October 25, 2017

RE: Variance number 18023
De Amicis Mutual Aid Society

D

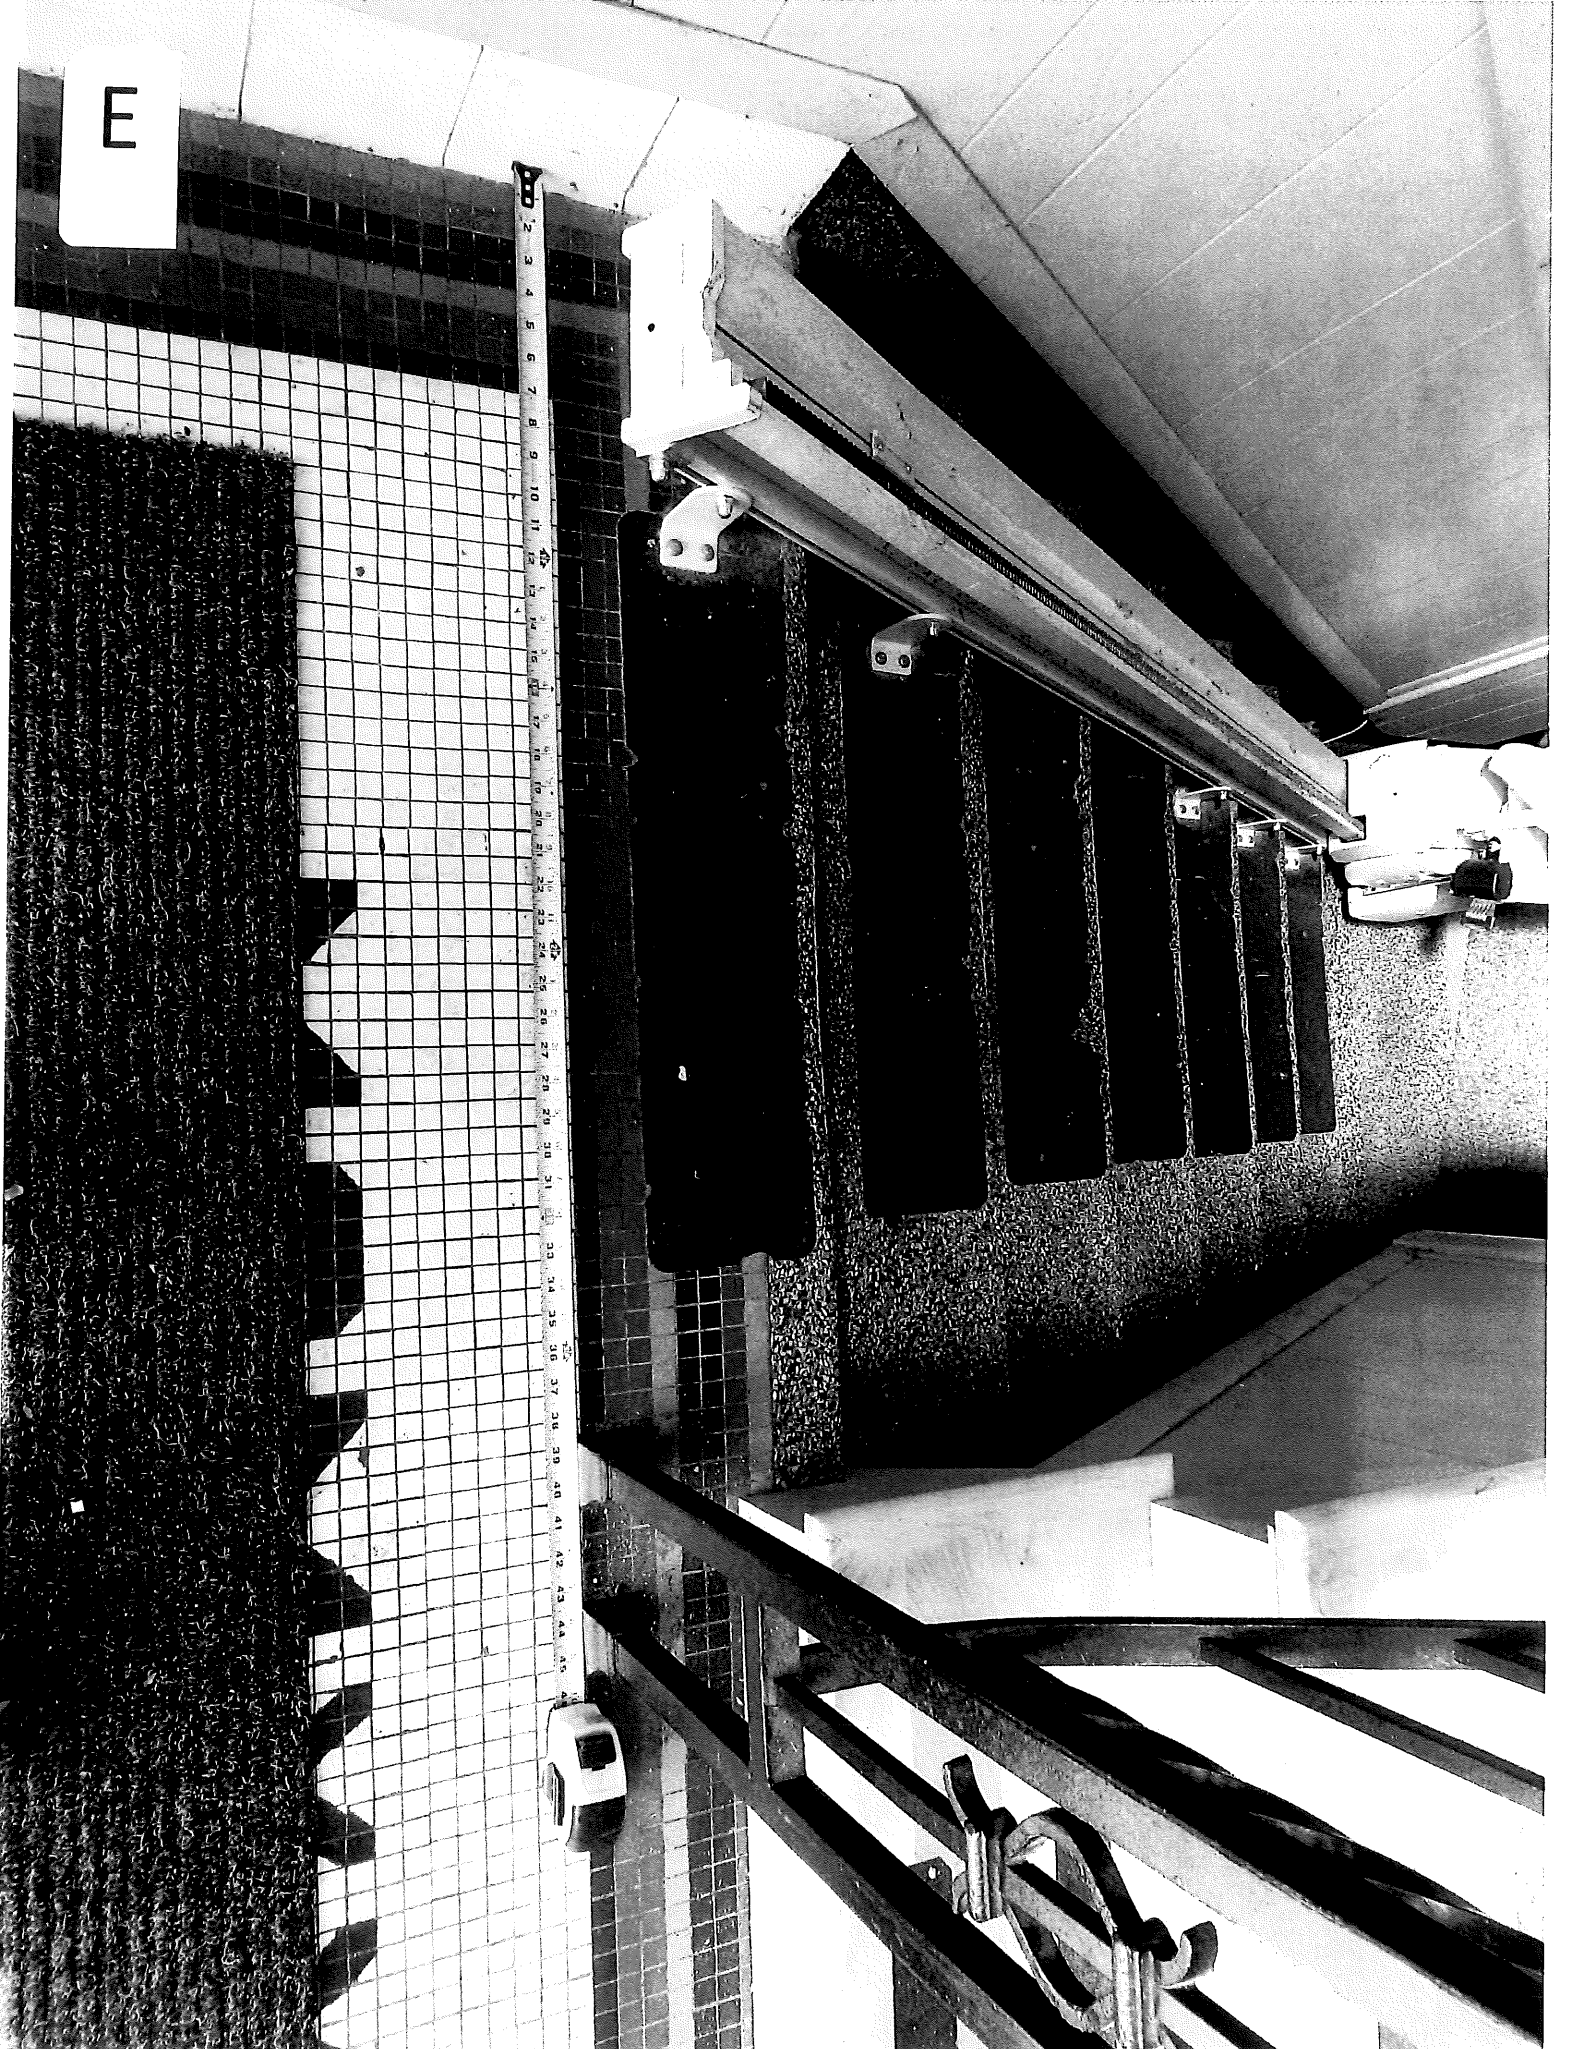
The chair lift was installed and protrudes into the path of exit discharge keeping the occupants from exiting the building while in use or restricting them if not in use. If someone is using the chair lift the other occupants of the basement will have to wait while the chair has stopped, the party using it has stood up and the seat of the lift has been returned to the upright position. If another person needs to use the lift to exit the basement, the chair will have to be returned to the lower level for the next person. This process hinders the expeditious and emergent response to evacuate the building in the event of an emergency situation. This lift is in direct violation of the following Indiana Fire and Building Codes.

Exhibit D shows the stairs with the chair lift.

G

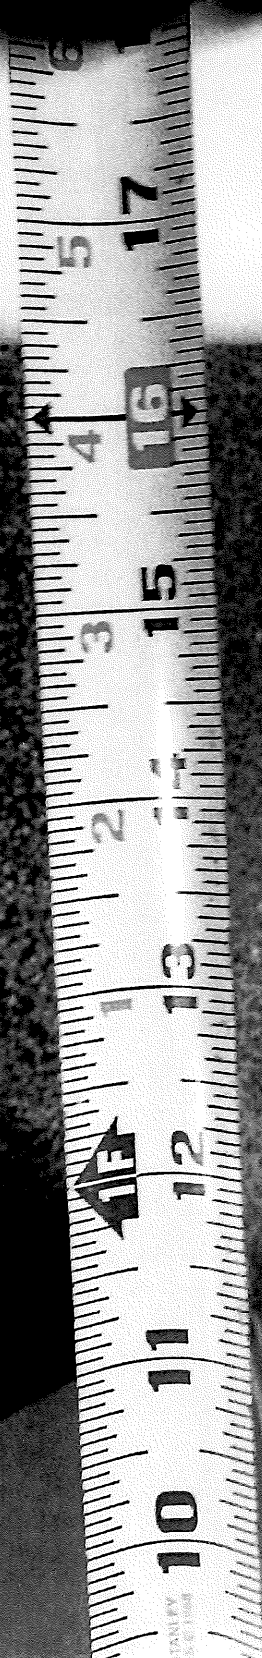
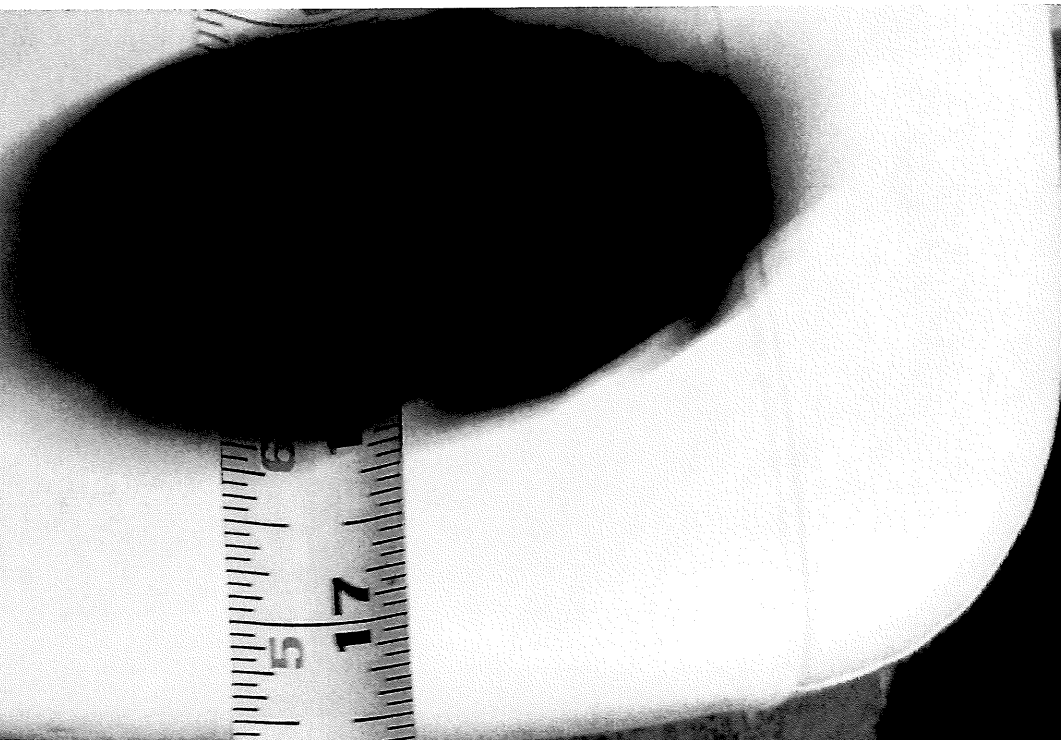
Exhibit G and H show the measurement width of the stairs at the front edge of the lift to the opposite wall.

The staircase measures approximately 38 5/8" at the widest point. Exhibits E and F. The staircase measures approximately 25 1/8" at the widest point of the lift. Exhibits G and H. This is not including the handrail which is 3 3/8" which makes the stairs 21 5/8" at the widest point from the chair to the handrail. The stairs were built to accommodate the occupancy load for the basement. With installing the lift it compromises the Means of Egress Continuity, Section 1003.6.

K

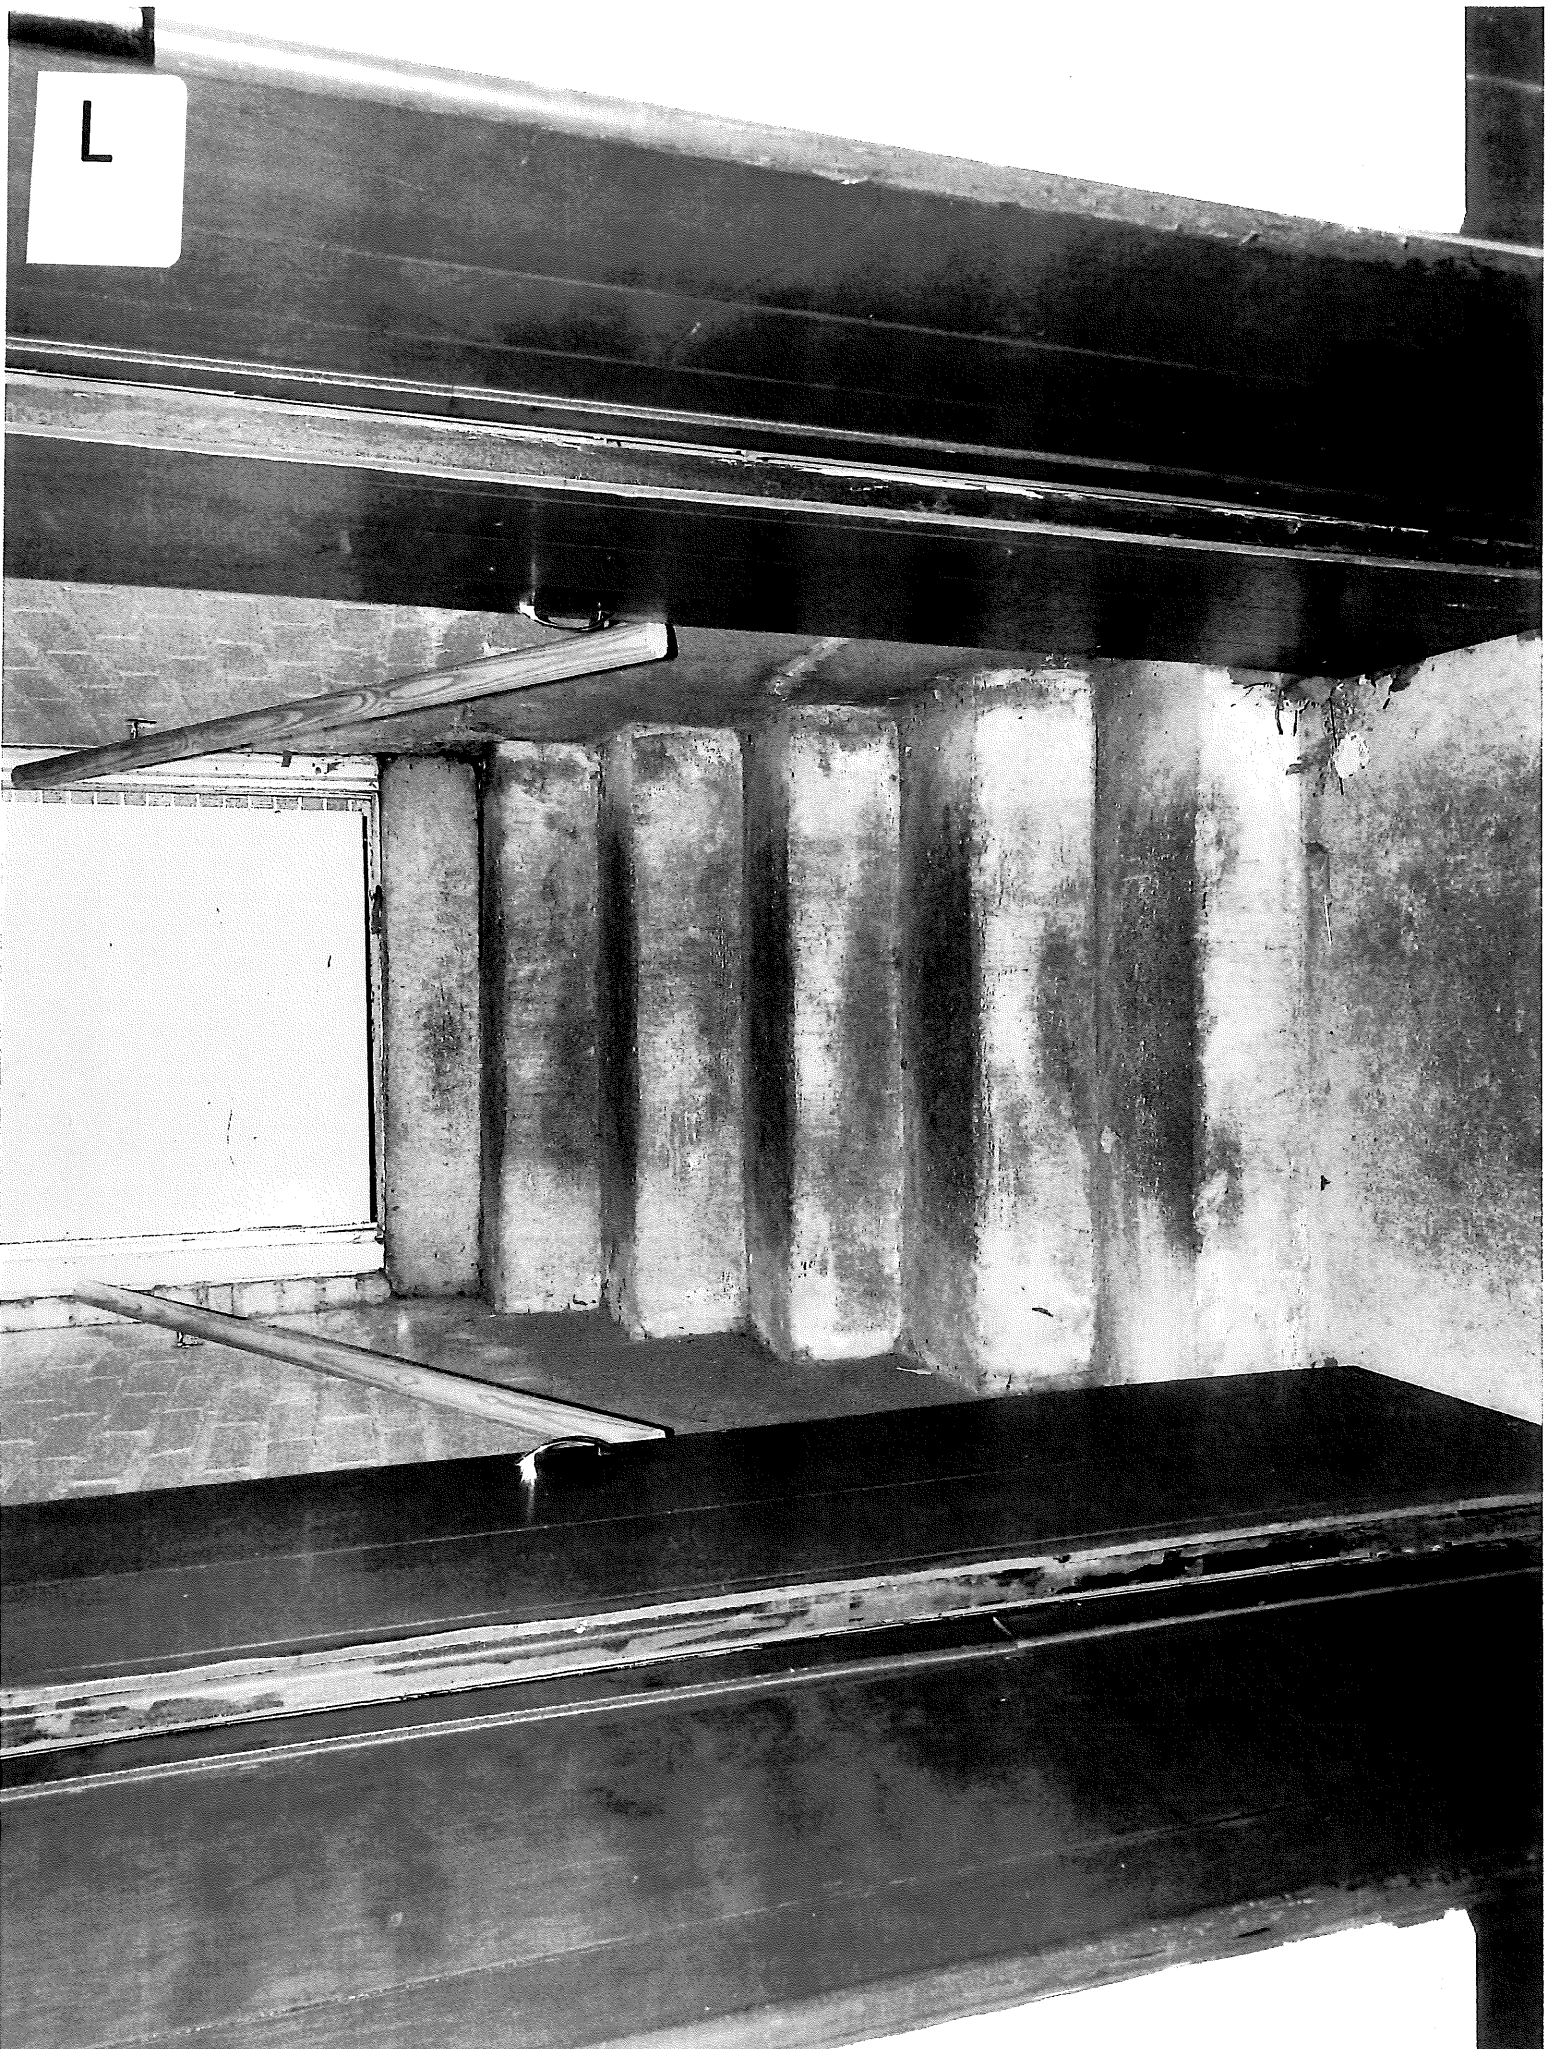
Exhibit K shows the measurement width from the front edge of the lift to the opposite handrail

M

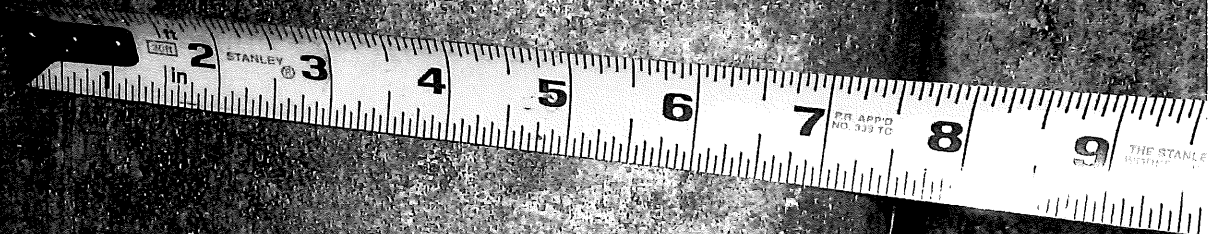
In the variance they mention a second exit from the basement. This exit is not maintained regularly. The stairs are made of concrete. Exhibit L. The rise of the steps is shown in Exhibit M. The treads are of different sizes. Exhibits N, O, P, Q, R. The exhibits were photographed from the lower level to the exit door. The treads range in depth from 8 5/8" to 9 7/8". The treads do not have a slip-resistant surface in accordance with Section 1003.4 IBC.

N

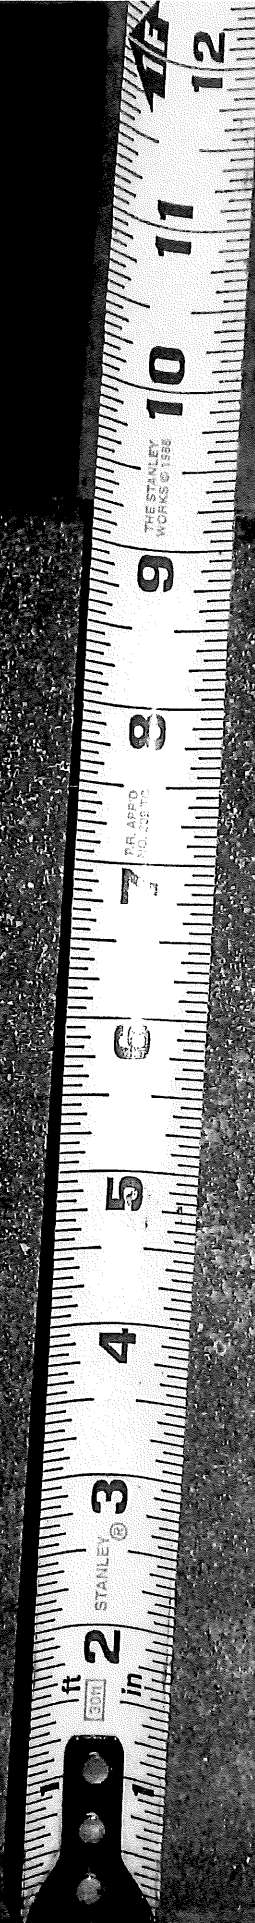
Exhibit N is the first step out of the lower level
